**MEETING OF THE  
PLANNING AND ZONING BOARD  
QUASI-JUDICIAL PUBLIC HEARING**

**November 18, 2014**

**Subject:** Site Development Plan Application  
9201 WBH TH – 8 DU Townhouse Complex (2<sup>nd</sup> Review)  
9201 W. Bay Harbor Drive  
Bay Harbor Islands Acct. No. MB2014-98  
MMPA Acct. No. 01-0702-0996

**Subject:** Site Development Plan Application  
Request for Modifications To 1/21/14 PZB Approved Plans  
93 Bay Harbor Townhouse Complex (6 DU)  
1055 93<sup>rd</sup> Street  
Bay Harbor Islands Acct. No. MB2013-161  
MMPA Acct. No. 01-0702-0977

**A-3.01**

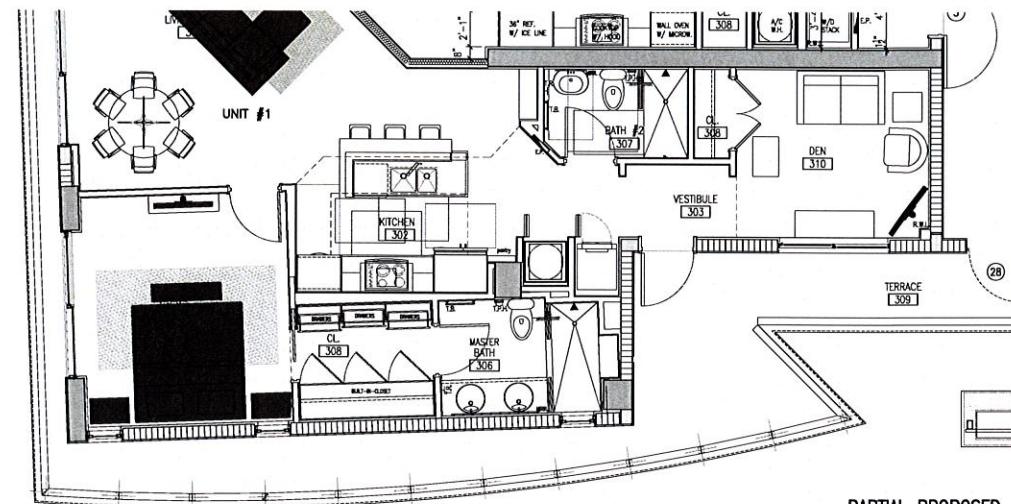
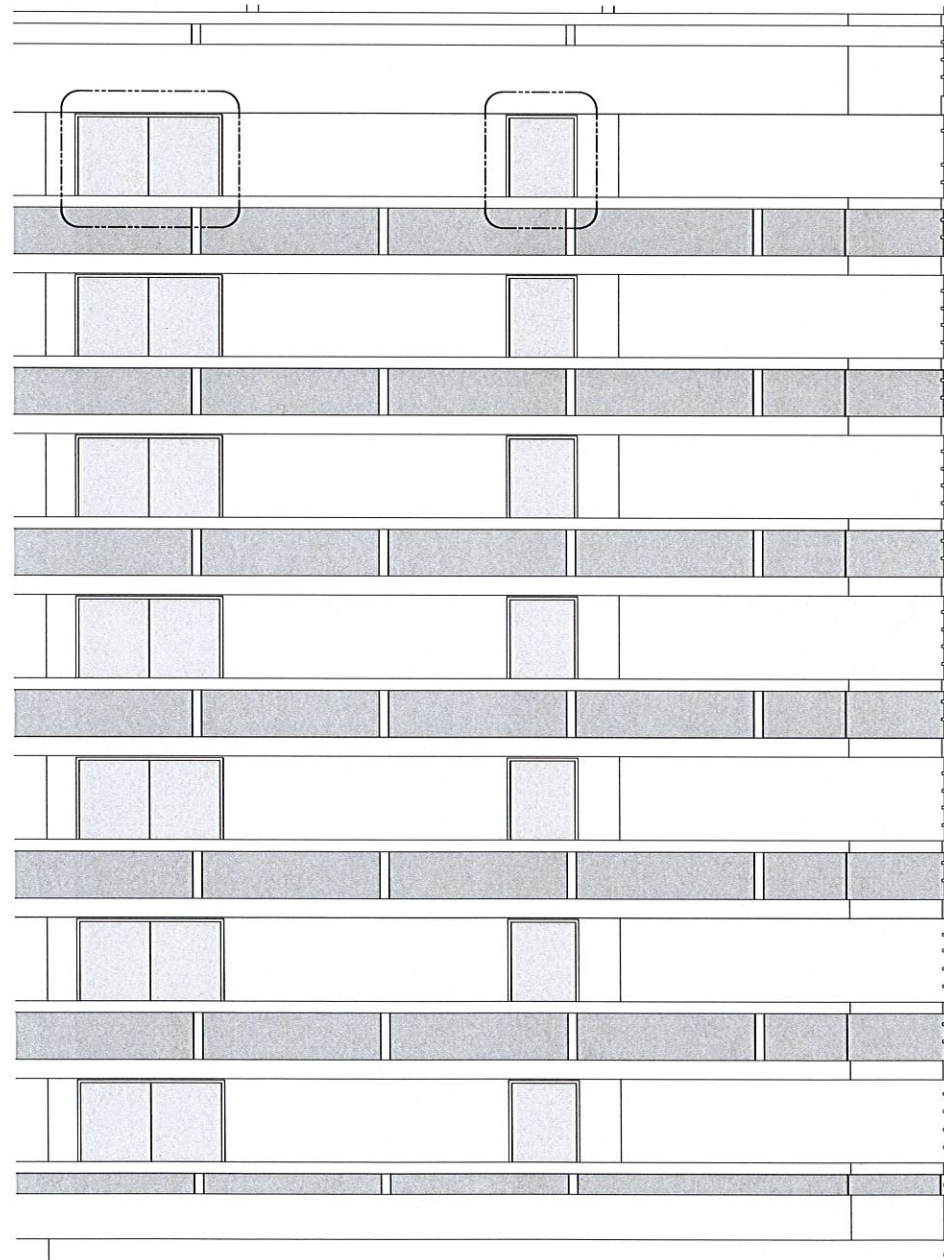
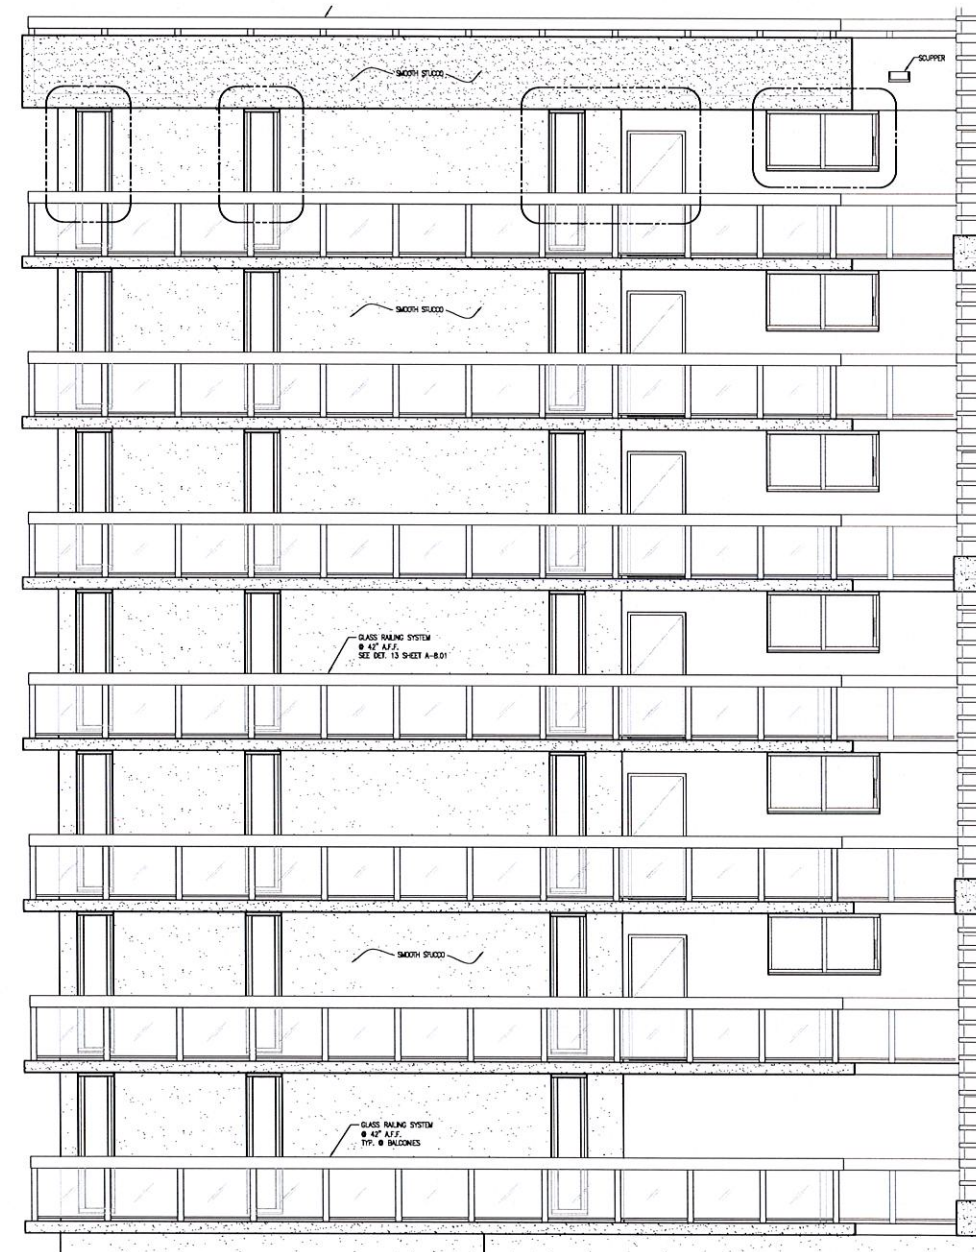
- 1) After the PZB approved the plans, the applicant requested to change / move some of the windows due to interior floor plan refinements. On Sheet A-3.01 the west building elevations show that some windows were removed and window placements differ from the PZB approved plans. **PZB approval is being requested for the design change.**
- 2) After the PZB approved the plans, the applicant requested to enlarge the footprint of the waterfront amenity area including terraces, a fountain, a shallow fountain, and more expansive seating areas. The landscape plan shows that the proposed change for the site still exceeds the 20% "green" landscape requirement. **PZB approval is being requested for the design change.**

WEST ELEVATION (PROPOSED)

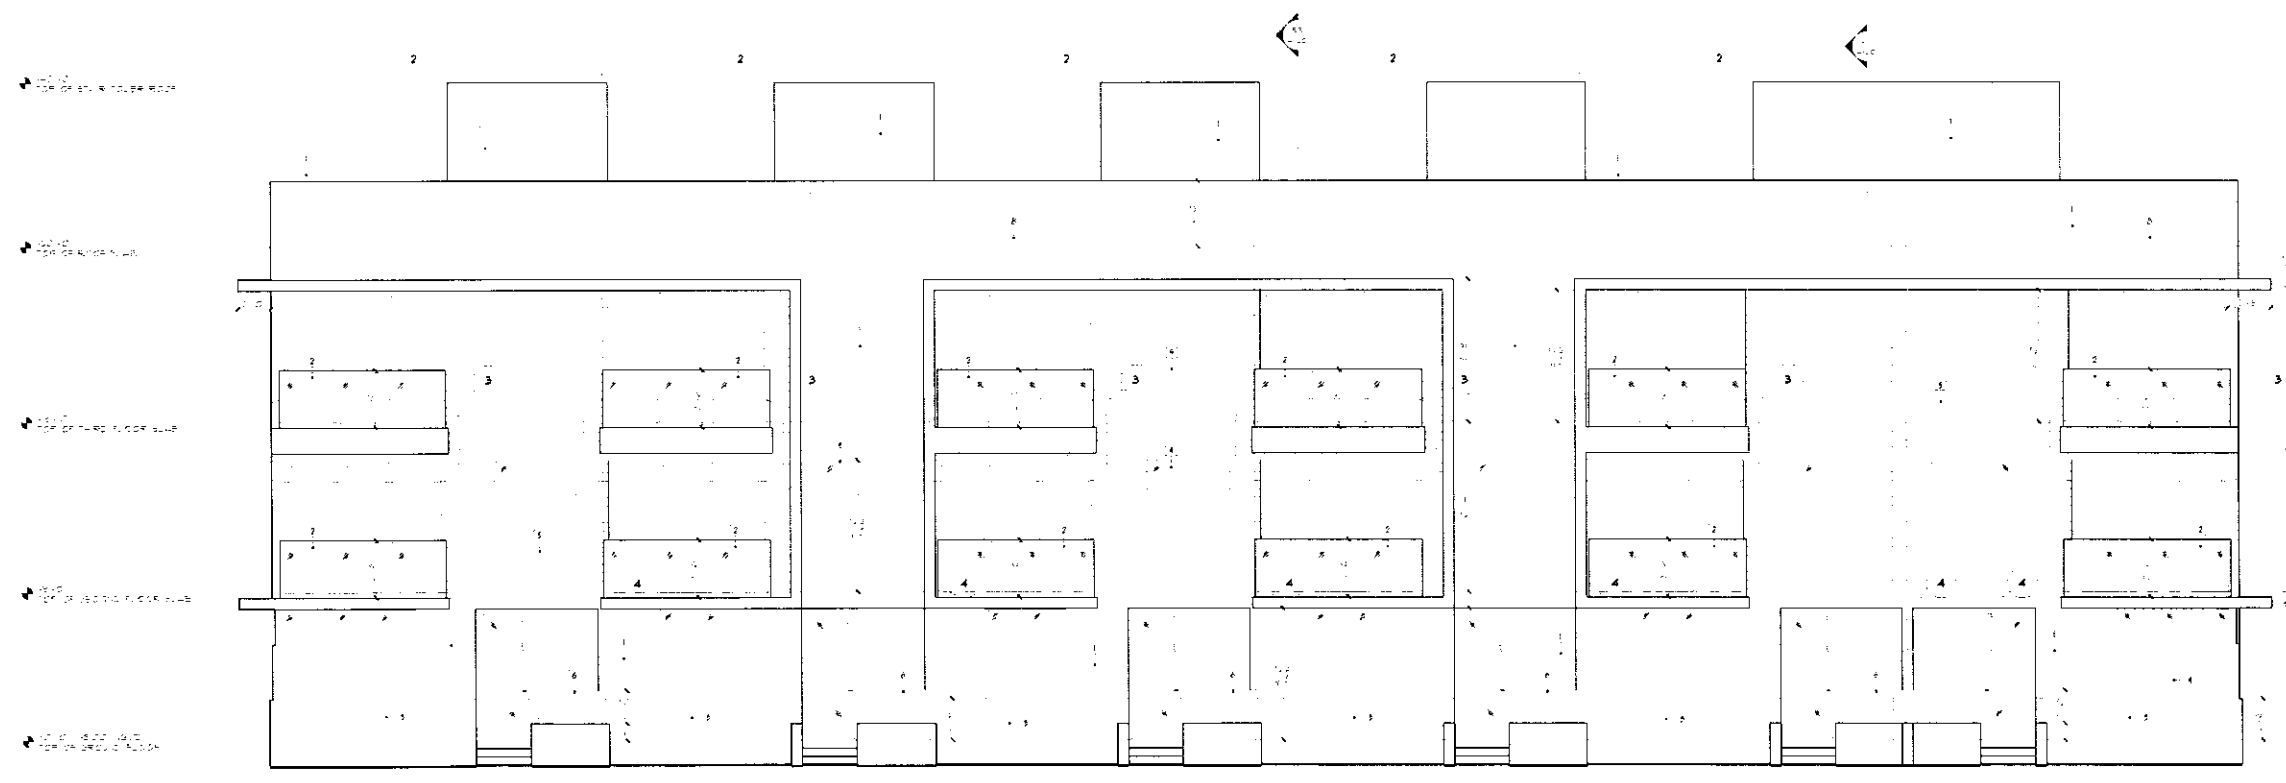
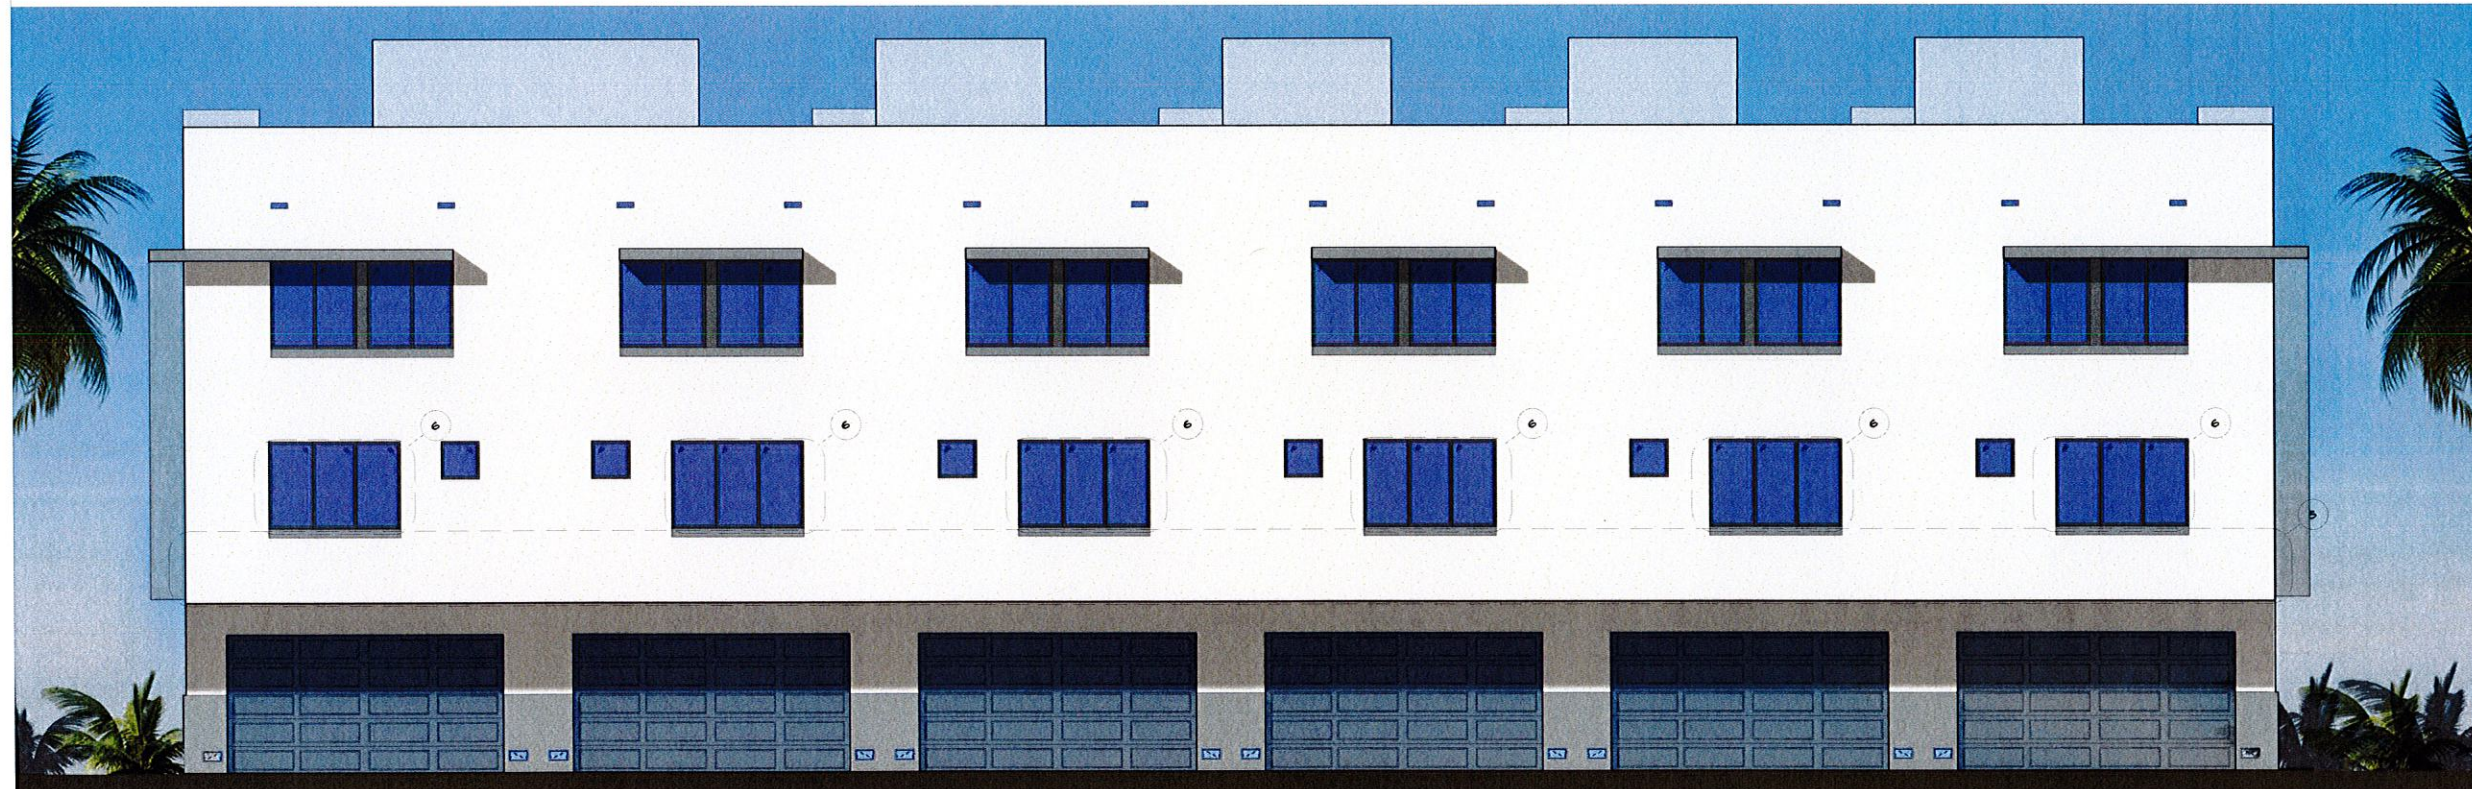
- 1) On Sheet A-201 the east building elevations show that some windows were removed and window placements differ from the PZB approved plans. Near the door entries, a small window was deleted from most of the units. Between the 2<sup>nd</sup> and 3<sup>rd</sup> levels a continuous smooth band was removed between some of the units. Some portions of the rooftop parapet wall / rooftop structures was also changed. **PZB approval is being requested for the design change.**

- 2) On Sheet A-201 the west building elevations show that the 2<sup>nd</sup> level and 3<sup>rd</sup> level window designs and garage door design differ from the PZB approved plans. Some portions of the rooftop parapet wall / rooftop structures was also changed. **PZB approval is being requested for the design change.**

NORTH ELEVATION (PROPOSED)

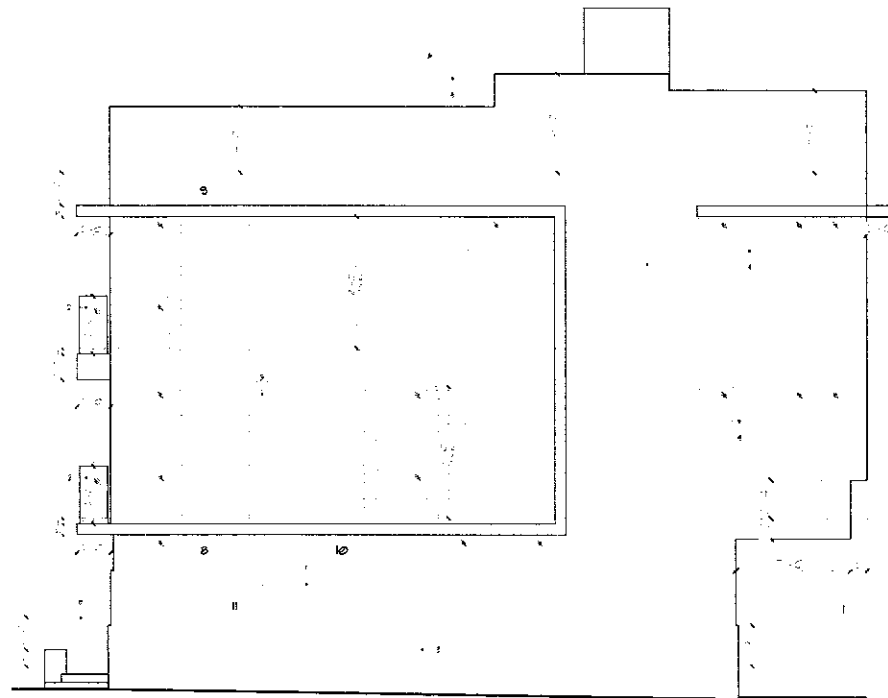
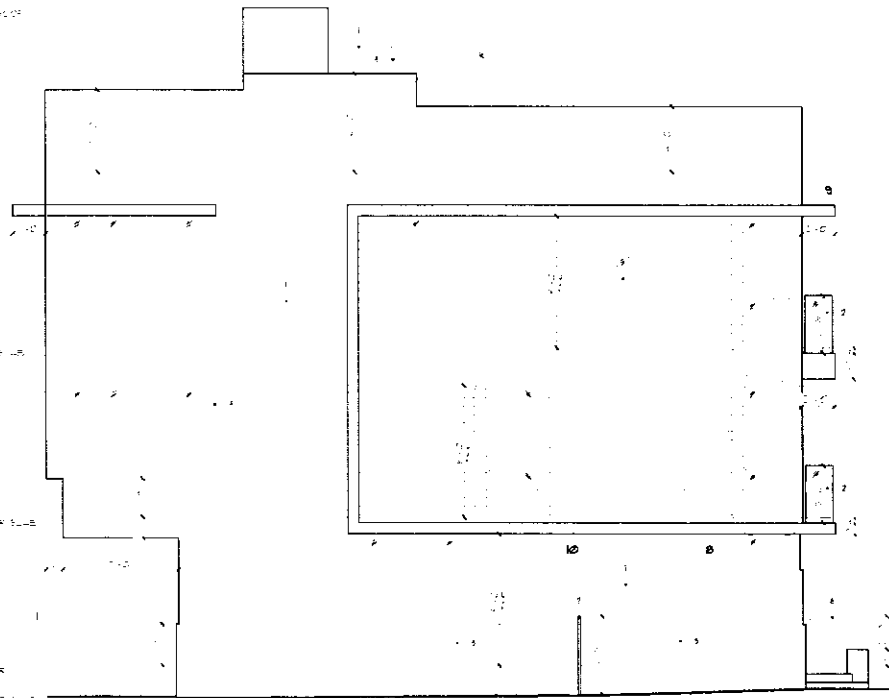
- 3) On Sheet A-202 the south building elevations show that some windows were removed / added and window placements differ from the PZB approved plans. Also, the balcony design is different (does not project out as far / railing different). It appears some of the rooftop parapet walls / structures were also modified. At grade level, a sliding door was removed. It appears windows were added to the rooftop structures (stairs tower). **PZB approval is being requested for the design change.**

- 4) On Sheet A-202 the north building elevations show that some windows were removed / added and window placements differ from the PZB approved plans. Also, the decorative cladding was enlarged significantly. Some of the rooftop features are different as well. It appears windows were added on some of the rooftop structures (stairs tower). **PZB approval is being requested for the design change.**

## LANDSCAPE PLAN

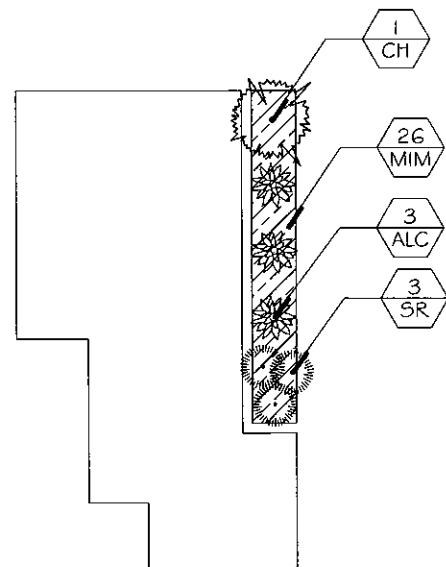
- 5) The Landscape plans are significantly different then the PZB approved set. It appears to still meet the minimum Code requirements. **PZB approval is being requested as the design of the Landscape Plan has changed.**
